Fw: Addington New Cross Central - CDN/22/0804 - External Lighting

Subject: Re: CDN/22/0804

Terrace Parapet Lighting

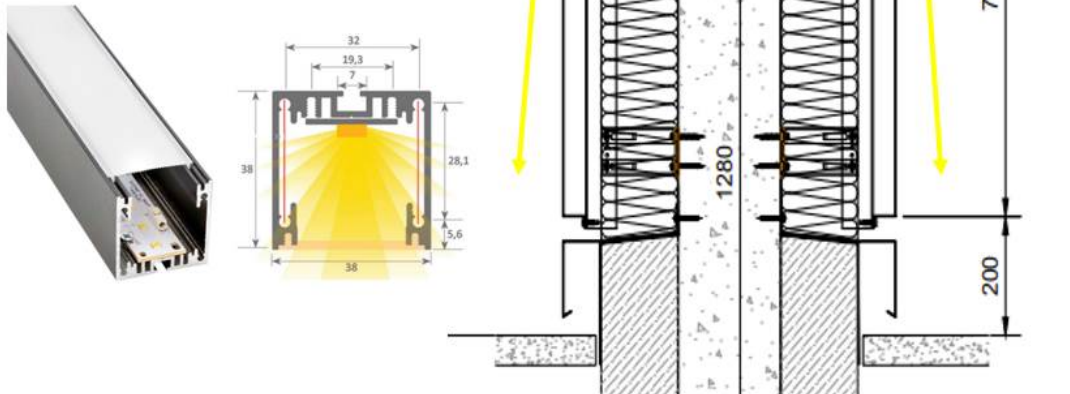
- Further details are also required for the proposed roof-top terrace lighting in order to avoid excessive upward light spill - Please extract below, the LED is positioned to wall wash the parapet, it is cloaked by the capping so the light is only projecting downwards.

The LED is fixed underneath the parapet coping orientated to wash the cladding beneath and the floor with low level light.

Infinitas 230V Flexible 230V LED tape fixed in a housing with an opal diffuser.
